# Cologne Cathedral (Germany)

No 292 rev

## 1. BASIC DATA

Map showing the revised boundaries of the property

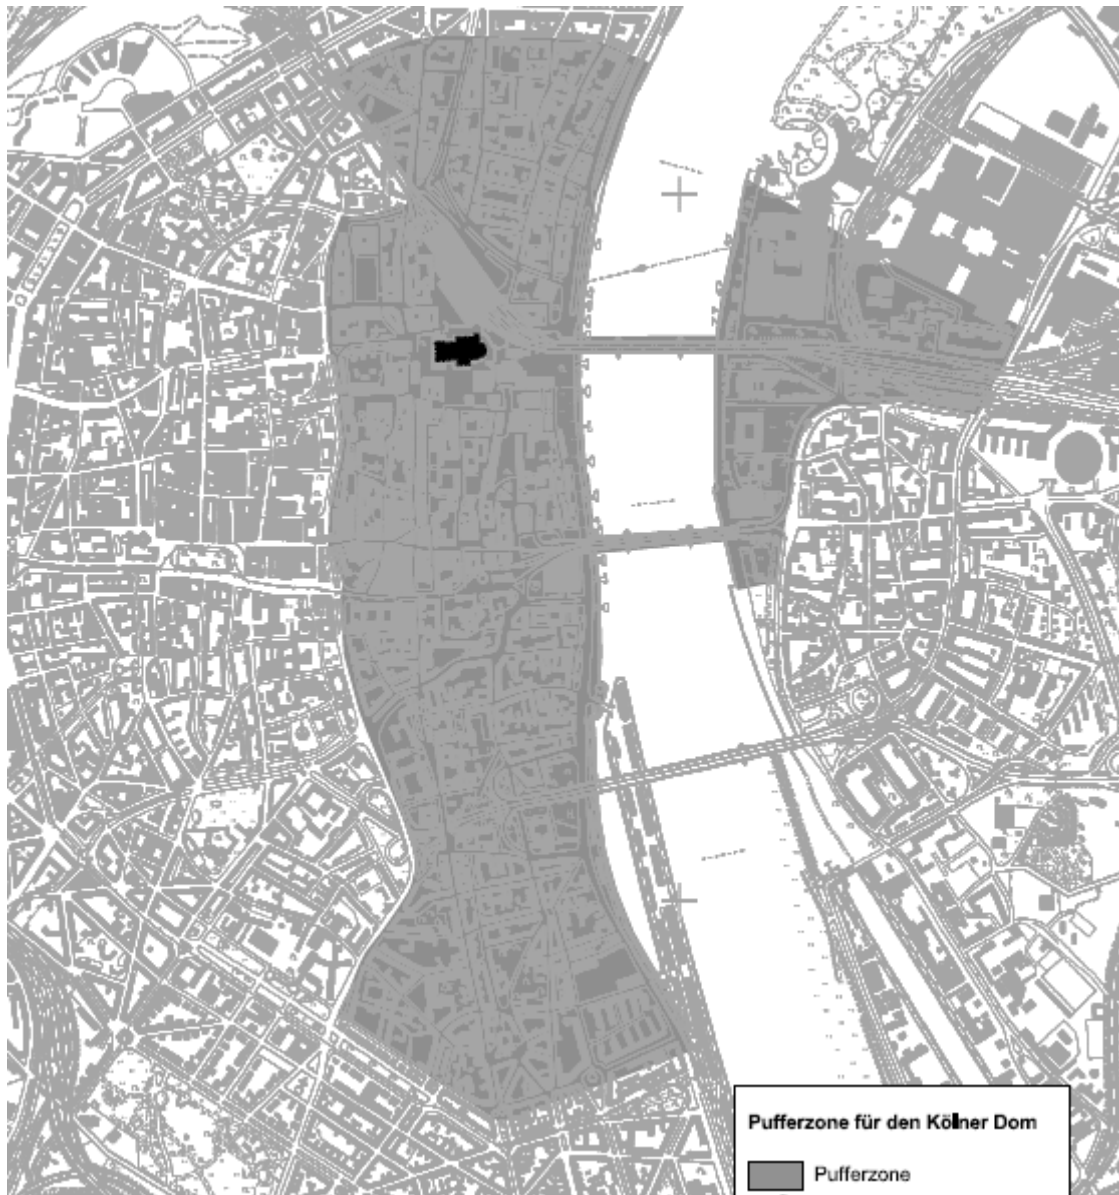
ICOMOS notes with satisfaction that the criteria of visual integrity of the cultural landscape defined by Cologne Cathedral have been taken into consideration. ICOMOS considers that the definition of the new buffer zone meets the criteria relating to visual integrity and the cultural landscape of the cathedral in its urban setting, in accordance with the previous recommendations of the World Heritage Committee and the Vienna Memorandum (2005). The new zone is appropriate to ensure the expression of the property's outstanding universal value. The protection measures which apply to the new buffer zone must however be specified in more detail.

ICOMOS notes that the definition of the new buffer zone is purely geographical. It could also be supported by historical criteria, particularly on the western limit of the western part of the buffer zone on the left bank. It could follow the medieval boundary of the historic town, which would enable the inclusion of five historic churches in Cologne, including that of the archbishop-elect of the Holy Roman Empire of the German nation.

ICOMOS recommends that the minor modification to the boundaries of Cologne Cathedral, Germany, be *approved*.

ICOMOS requests that the protection measures which apply to the new buffer zone should be specified in more detail, thereby supplementing the management plan.

ICOMOS recommends that reflection should continue concerning the limits of an extended buffer zone based on historic criteria.
